# APPLICATION

PERCOLATION TESTING

HOWARD COUNTY HEALTH DEPARTMENT  
BUREAU OF ENVIRONMENTAL HEALTH  
P.O. BOX 476 ELLICOTT CITY, MARYLAND 21043  
TELEPHONE: 461-9933

Farside Lts 65

SOIL PROFILE

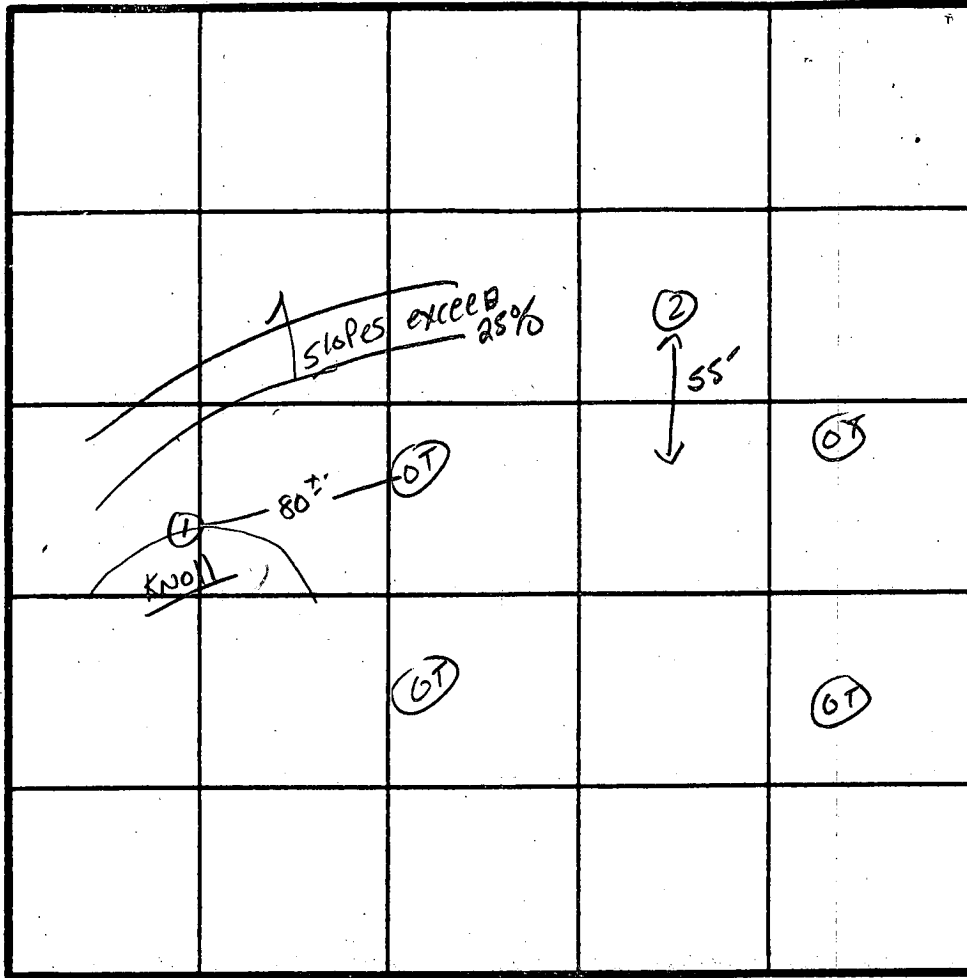
REASONS FOR REJECTION OR HOLDING only marginal movement allowed. S. Abul

NEW SEPTIC EASEMENT

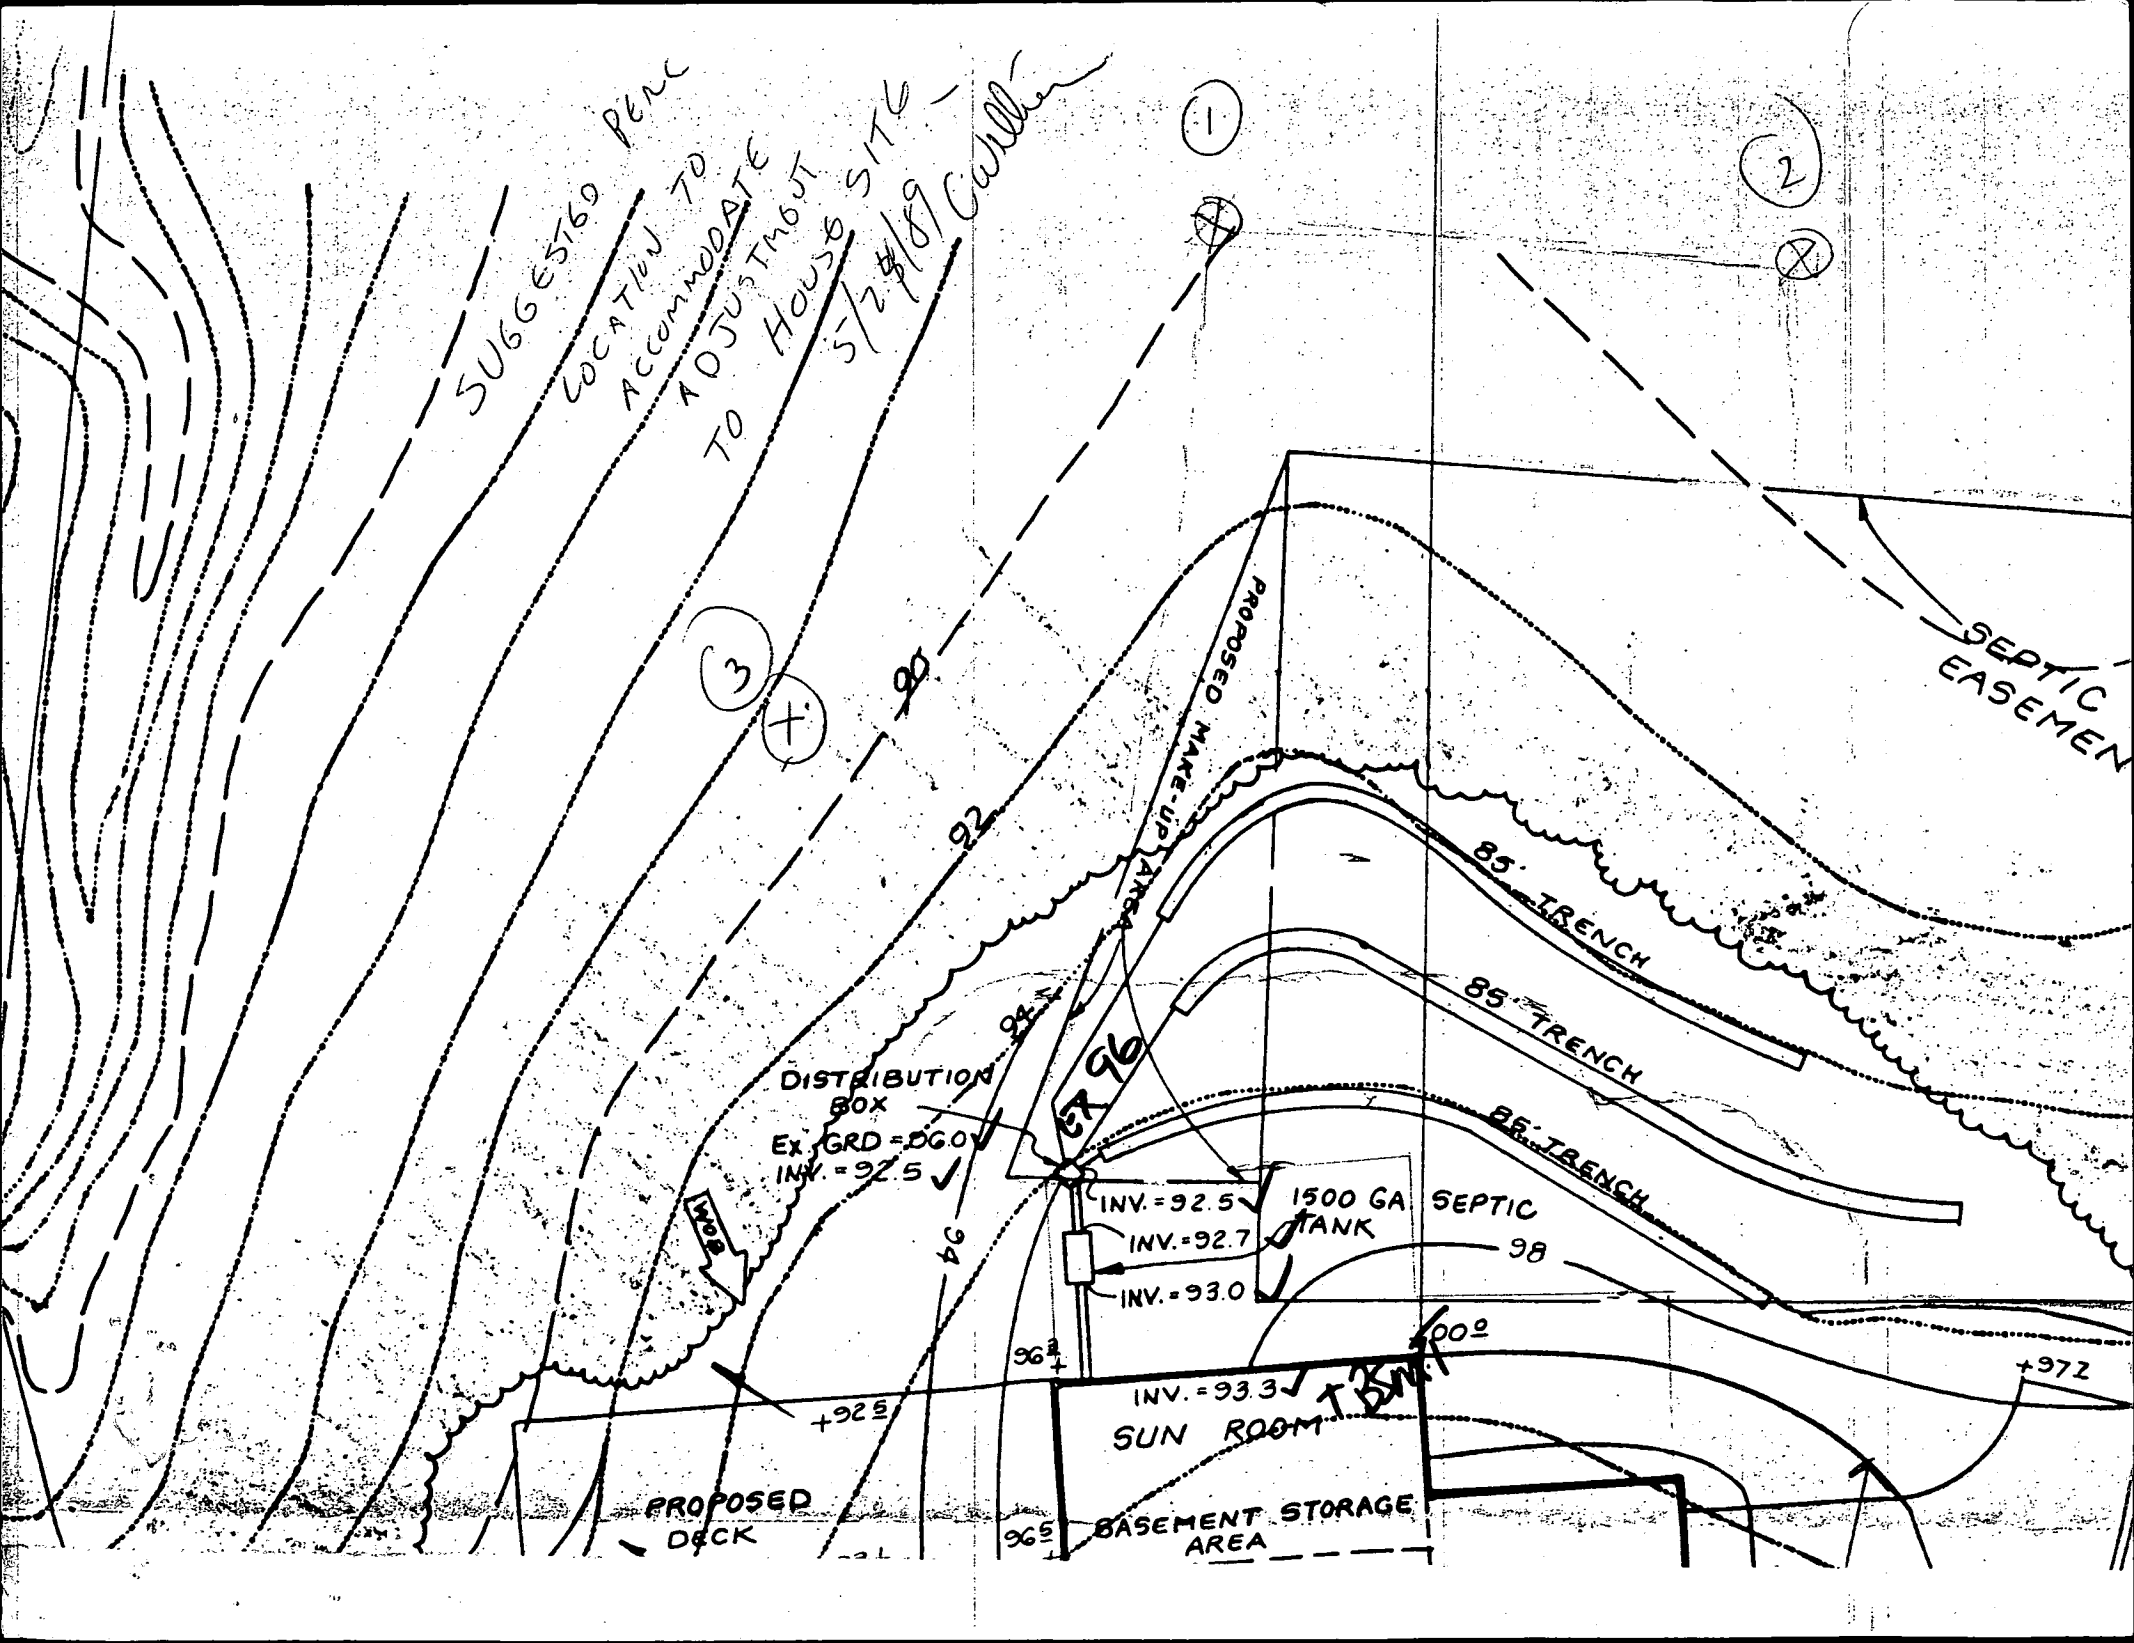
SUGGESTED PENC  
LOCATION TO  
ACCOMMODATE  
ADJUSTMENT  
TO HOUSE SITE  
5/28/89 *Carroll*
